Estimate for the construction of a Treasure Vault for a Taluq Cutcherry to accompany G. O. No. 3,074, *dated 26th September* 1866.

PLAN, SECTION AND DETAILS OF A TREASURE VAULT,

TALUQ CUTCHERRY.

VIDE G. O. Nº 3074 DATED THE 26TH SEPTEMBER 1866

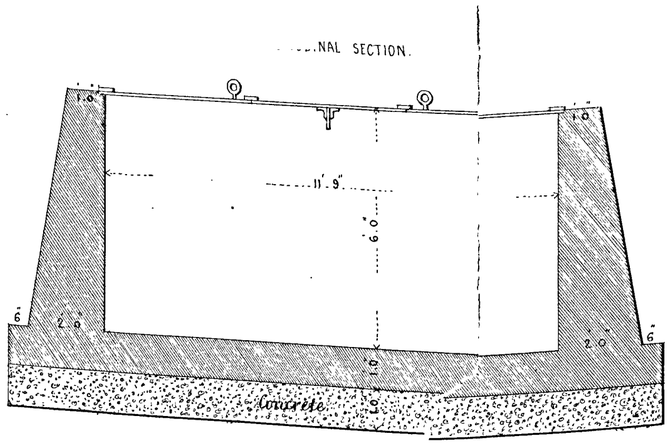
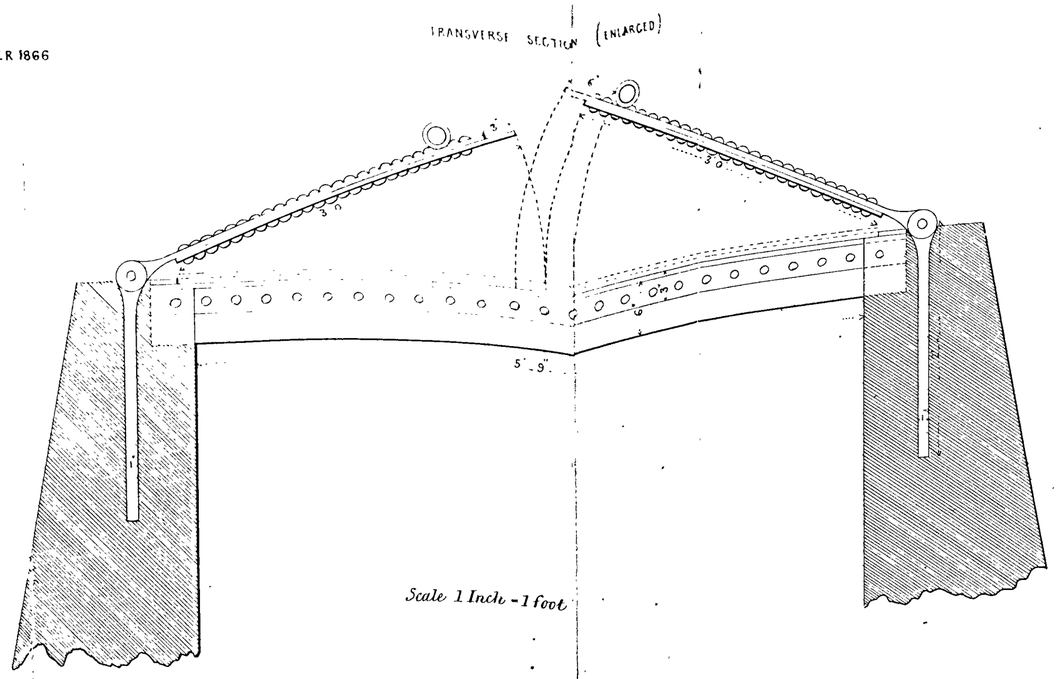
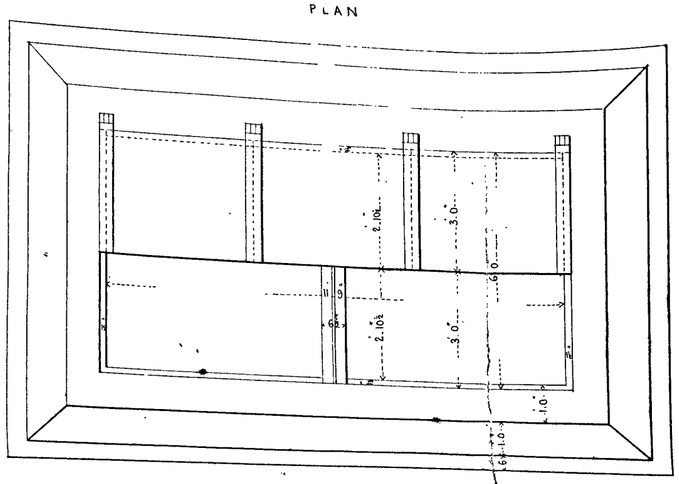
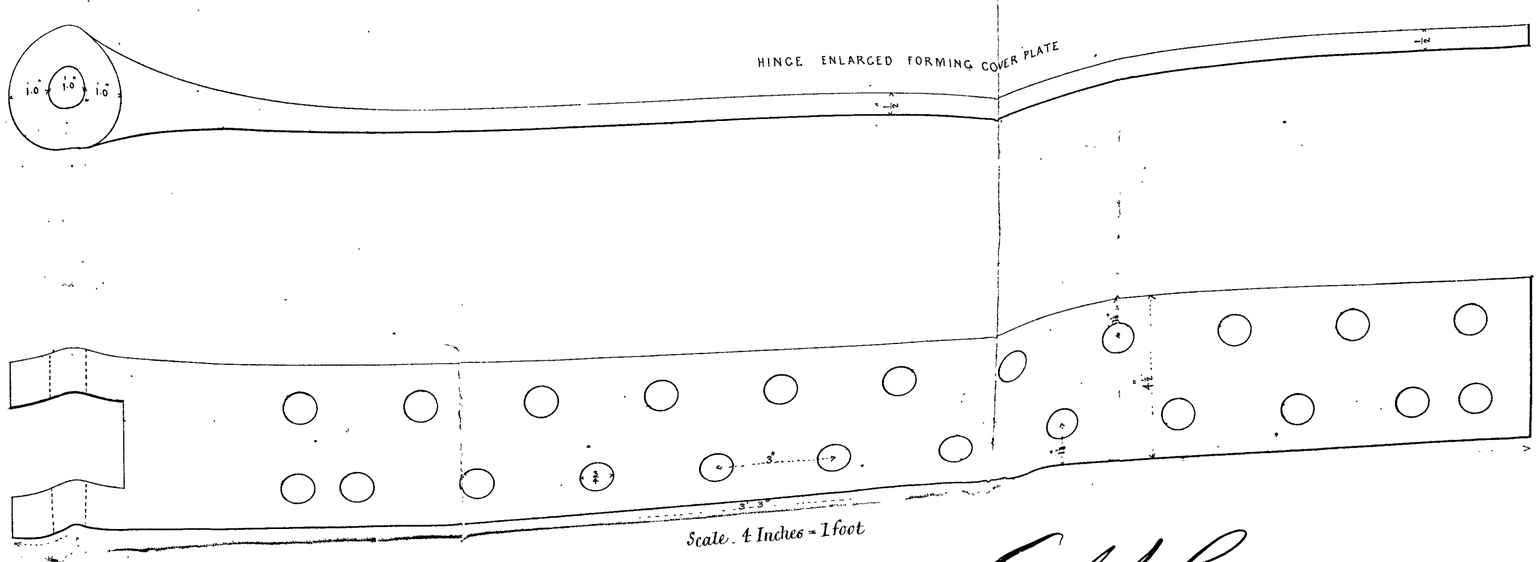
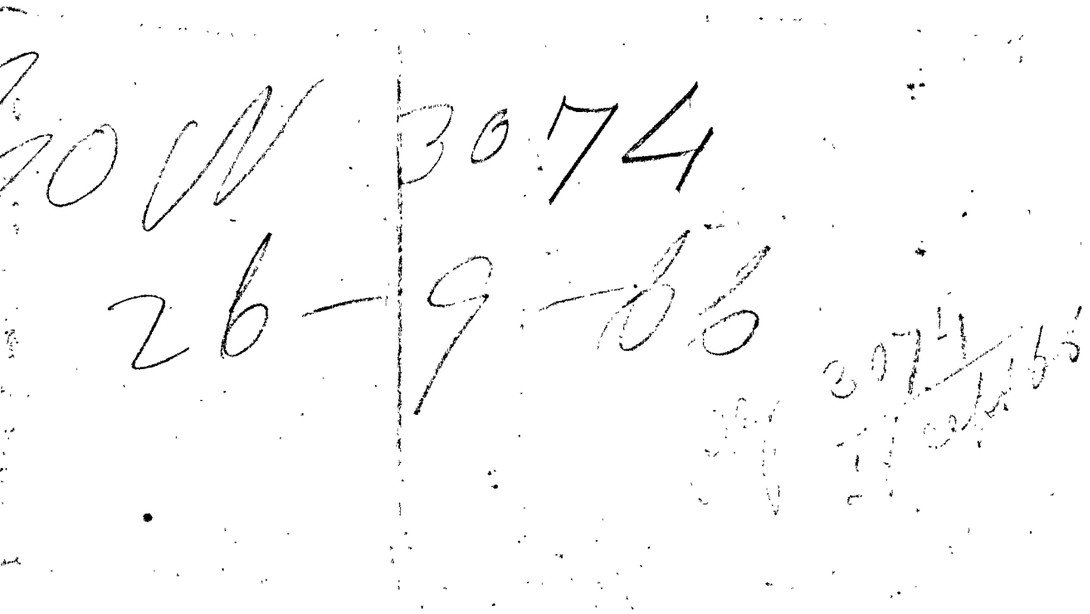
2. With reference to paragraph 2, I consulted with the Superintending Engineer regarding an alteration in the Talook Treasury room. At his request the Executive Engineer has furnished me with a plan and estimate, (herewith sent,) amounting to Rupees 680, for a cut-stone lined cellar with iron doors to be substituted for the room in the standard plan. I quite approve of the alteration, and beg to be favored with the Board's instructions on the subject, so that the proposed alterations may be made in the Peddapoor Talook Treasury room.

1. The Board have admitted the defective arrangement for the Treasury in the present standard plan of a Talook Treasury, which impedes vision and ventilation and blocks the open space, and they entirely approve the proposal to substitute a Treasure cellar or vault for the present room.

2. The plan provides a vault with a clear space inside of feet 11-9 long, by feet 5-9 wide, and feet 6 deep, and the total cost of the building will not be enhanced.

1. The Board have admitted the defective arrangement for the Treasury in the present standard plan of a Talook Treasury, which impedes vision and ventilation and blocks the open space, and they entirely approve the proposal to substitute a Treasure cellar or vault for the present room.

2. The plan provides a vault with a clear space inside of feet 11-9 long, by feet 5-9 wide, and feet 6 deep, and the total cost of the building will not be enhanced.

1. The Government sanction the substitution of a Treasure cellar or vault of the description given in paragraph 2 of the Collector's letter, recorded in the foregoing Proceedings, in lieu of the Treasury room in the Talook Cutcherries of Amalapoor, Ramachendrapoor, and Peddapoor, in the Godavery District, which have been and are being built on the new standard plan.

1. The Government sanction the substitution of a Treasure cellar or vault of the description given in paragraph 2 of the Collector's letter, recorded in the foregoing Proceedings, in lieu of the Treasury room in the Talook Cutcherries of Amalapoor, Ramachendrapoor, and Peddapoor, in the Godavery District, which have been and are being built on the new standard plan.
